# Performance Bulletin

May 2007

## Motor Change for 9000, 9100, & 9500 Valves

**New Assembly  
(Motor, Ground Plate, & Label)**

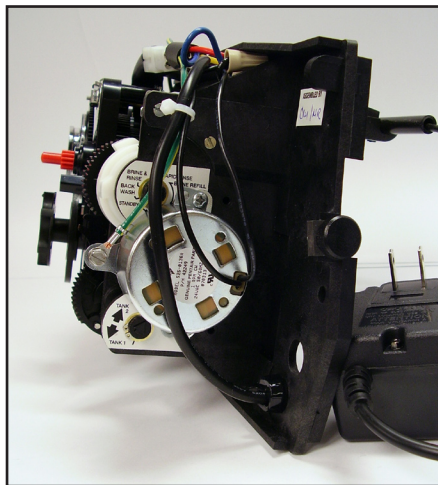
Effective on May 14, 2007, there will be a new 24V motor for the 9000, 9100, and 9500 valves. The new motor will be 4 watt (the previous was 2.7 watt), and boasts an all-metal gear train. The label and grounding plate will change to facilitate the new motor. Additionally, an instruction sheet will be included with the service kit.
